SUBJECT: Clinton Landfill

Attached is Water Division's evaluation of the geology and hydrogeology beneath the Clinton Landfill in DeWitt County, Illinois.

Clinton Landfill Evaluation

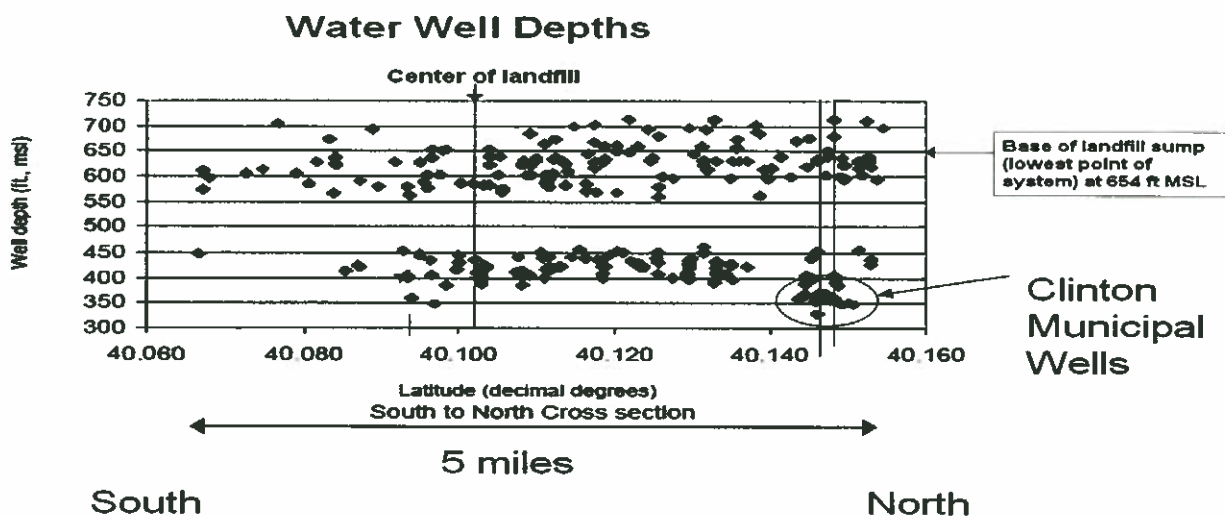
- 3) Liner materials will eventually deteriorate allowing leachate into the substrate. Note: the only citation referenced by Lee and Lee-Jones is a report which they themselves wrote.

Response: Given the highly redundant and conservative nature of the liner *system*, leakage of leachate into the substrate is not expected. The system consists of three HDPE liners and two leachate collection systems over a three-foot thick layer of compacted clay which overlays at least 150 ft of native clay above the Mahomet Aquifer.
